# UNITED STATES PATENT AND TRADEMARK OFFICE

| APPLICATION NO.   | FILING DATE | FIRST NAMED INVENTOR      | ATTORNEY DOCKET NO.               | CONFIRMATION NO.       |
|---|-------------|---------------------------|-----------------------------------|------------------------|
| 10/783,499  | 02/20/2004  | George Gustave Zipfel JR. | Zipfel 1                          | 7599                   |

### Office Action Summary

## **DETAILED ACTION**

Push Pull illustration.

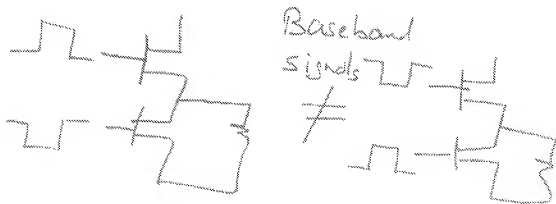
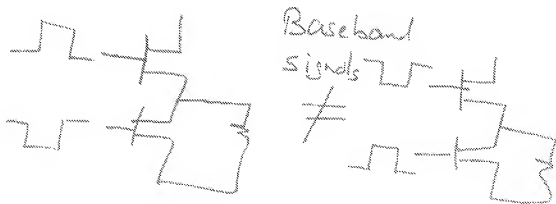
To further illustrate this fact that the baseband currents are of opposite magnitudes note the push and pull nature of the Prokin prior art, i.e. the "alternative" switching. See push pull illustration below.

In the Push Pull illustration note that with the exact opposite PWM signal applied to the "pull" transistor as compared to the "push" transistor the baseband signal just cannot be the same and are in fact 180 degrees out of phase with each other. To explain this in more simple terms note that when you filter out the high frequency signal what you have left is the width of the pulses defining how much the positive magnitude is (Push) and how much the "negative"(ground) magnitude is (pull). When the pull magnitude is at the highest in one push/pull arrangement the Push magnitude is at its highest in the other push/pull arrangement. In other words the baseband signals are opposite or 180 degrees out of phase between the two push/pull arrangements. (Note that the claims are drawn to structure so even if the examiner were to be incorrect in baseband signals are not the same for the two push pull circuits operated in an opposite manner as illustrated in the push pull illustration above, still applying the yet unclaimed disclosed control signals to the prior art does not impart patentability to the structure as the structure is the same and merely applying signals to an old structure that is different from the norm does not make that structure new. It is the same old structure. What applicant will be getting should this application become a patent is the right to exclude others from making the claimed structure. **There must be no "ambiguity" as to what that structure is.** See Halliburton Energy Services, Inc. v M-I LLC, Fed. Cir. 2007-1149. The examiner has constantly pointed to MPEP 2114 where the patent office requires this of the claims. Thus what is needed here in this application is clear limitations of structure to distinguish over the prior art so as to provide a clear indication to the public as to what structure applicant will be allowed to exclude others from making should this application become a patent.)

To further illustrate this fact that the baseband currents are of opposite magnitudes note the push and pull nature of the Prokin prior art, i.e. the "alternative" switching. See push pull illustration below.

In the Push Pull illustration note that with the exact opposite PWM signal applied to the "pull" transistor as compared to the "push" transistor the baseband signal just cannot be the same and are in fact 180 degrees out of phase with each other. To explain this in more simple terms note that when you filter out the high frequency signal what you have left is the width of the pulses defining how much the positive magnitude is (Push) and how much the "negative"(ground) magnitude is (pull). When the pull magnitude is at the highest in one push/pull arrangement the Push magnitude is at its highest in the other push/pull arrangement. In other words the baseband signals are opposite or 180 degrees out of phase between the two push/pull arrangements. (Note that the claims are drawn to structure so even if the examiner were to be incorrect in baseband signals are not the same for the two push pull circuits operated in an opposite manner as illustrated in the push pull illustration above, still applying the yet unclaimed disclosed control signals to the prior art does not impart patentability to the structure as the structure is the same and merely applying signals to an old structure that is different from the norm does not make that structure new. It is the same old structure. What applicant will be getting should this application become a patent is the right to exclude others from making the claimed structure. **There must be no "ambiguity" as to what that structure is.** See Halliburton Energy Services, Inc. v M-I LLC, Fed. Cir. 2007-1149. The examiner has constantly pointed to MPEP 2114 where the patent office requires this of the claims. Thus what is needed here in this application is clear limitations of structure to distinguish over the prior art so as to provide a clear indication to the public as to what structure applicant will be allowed to exclude others from making should this application become a patent.)
